Service Bulletin

Bulletin No.: 07-08-50-022B

Subject: Seat Rattle and/or Hard to Latch and Unlatch, Power Release Fold and Tumble Not Fully Functioning (Perform Repair as Outlined)

Models: 2007-2012 Cadillac Escalade, Escalade ESV
2007-2012 Chevrolet Suburban, Tahoe
2007-2012 GMC Yukon, Yukon XL, Yukon Denali, Yukon Denali XL

2040919

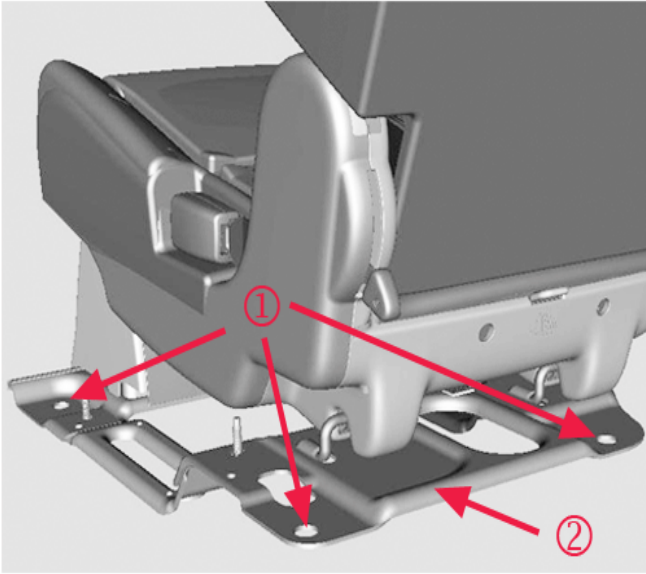
The condition may be caused by the floor being slightly lower in one corner of the second row seat mounting area, possibly affecting the alignment of the seat latches and the seat base plate.

1. Place the affected seat into the tumbled, or raised, position.
2. Verify that the seat latches on the bottom of the seat are fully opened.
3. Slowly lower the seat to rest the latches on the strikers; **Do Not** allow the seat to latch. Observe the seat latches to mating strikers for even contact or gap.

Inspect the second row seat for proper operation/latching, and adjust carpet fit and/or adjust leveling of the seat spacer plate to correct striker to latch fit, as necessary.

4. If there is even contact and no gap between the latches and strikers, observe the carpet for signs of not being fully seated, or being improperly installed. Mispositioned carpet may possibly hinder full motion of the latches down onto the strikers.
5. Correct any conditions that may be caused by the carpet, then retest seat latch function.
6. If a gap is present between one of the latches and the mating striker, measure the vertical gap.
